AMENDMENT TO FACILITY OPERATING LICENSE

ATTACHMENT TO LICENSE AMENDMENTS

SAFETY EVALUATION BY THE DIRECTORATE OF LICENSING

OCONEE NUCLEAR STATION, UNITS 1, 2 AND 3

OCONEE NUCLEAR STATION
STATION ORGANIZATION CHART
FIGURE 6.1-1 | 14/9/1

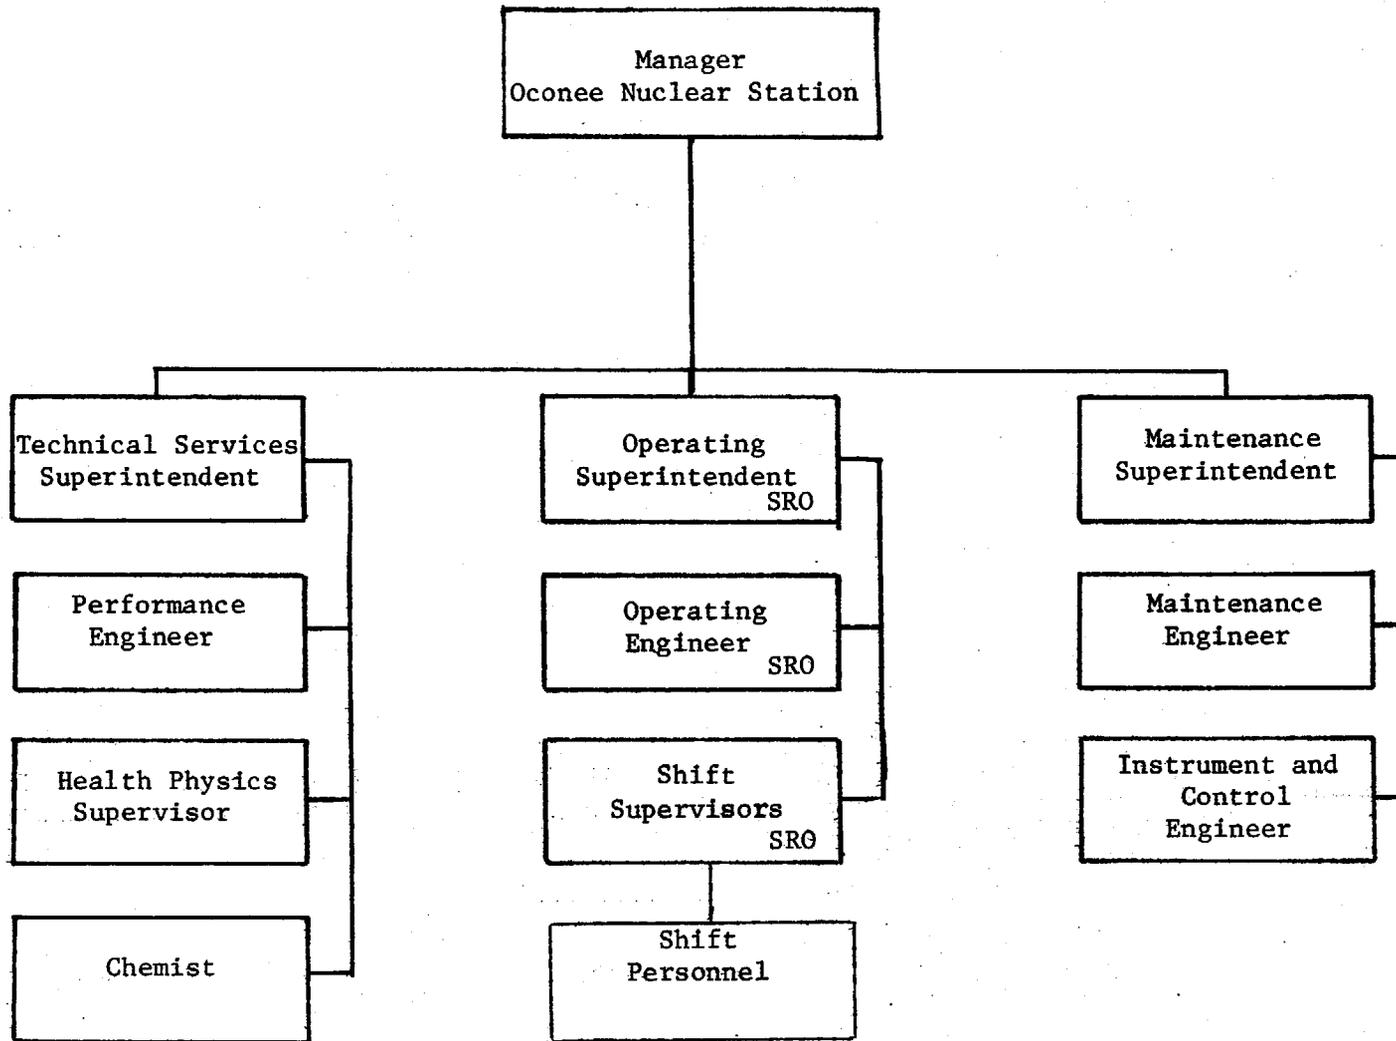
The following changes to the station organization chart have been proposed:

1. The title of Plant Superintendent will be changed to Station Manager.
2. The position of Assistant Plant Superintendent will be eliminated.
3. Clerical Staff and Visitor Center Staff will be removed from the chart.
4. The supervisor's titles in the two service groups and the operating group will be changed from Engineer to Superintendent.

FIGURE 6.1-2 | 14/9/1

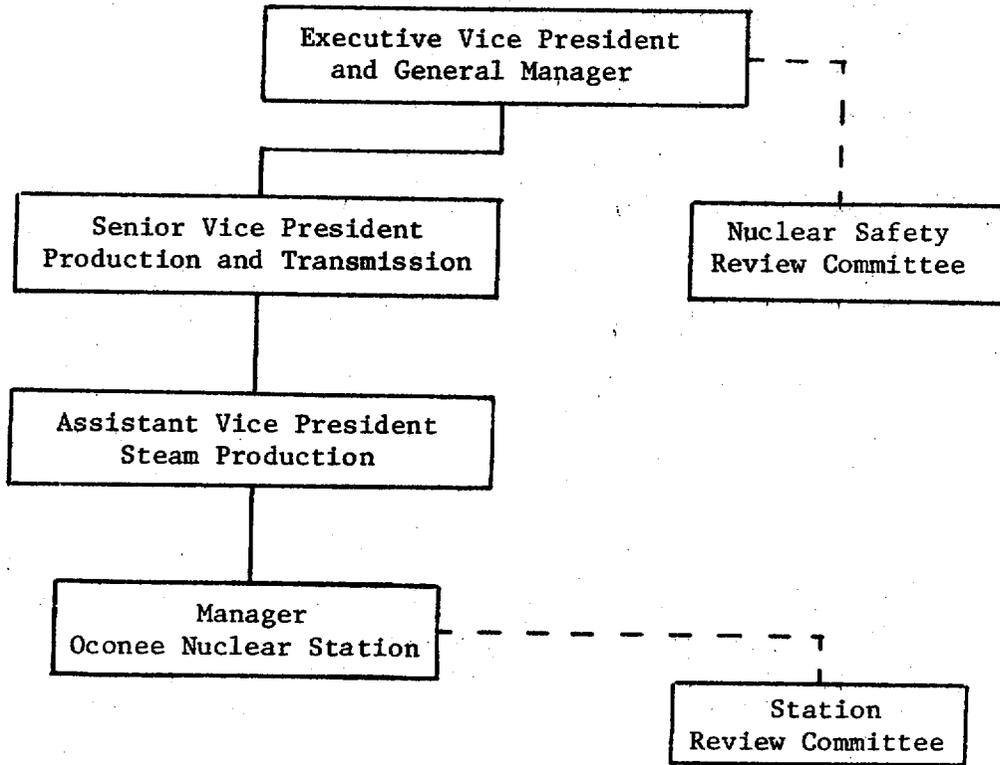
The proposed change in the management organization chart (Figure 6.1-2) will simplify the reporting channels for the Safety Review Committee and the Station Review Committee.
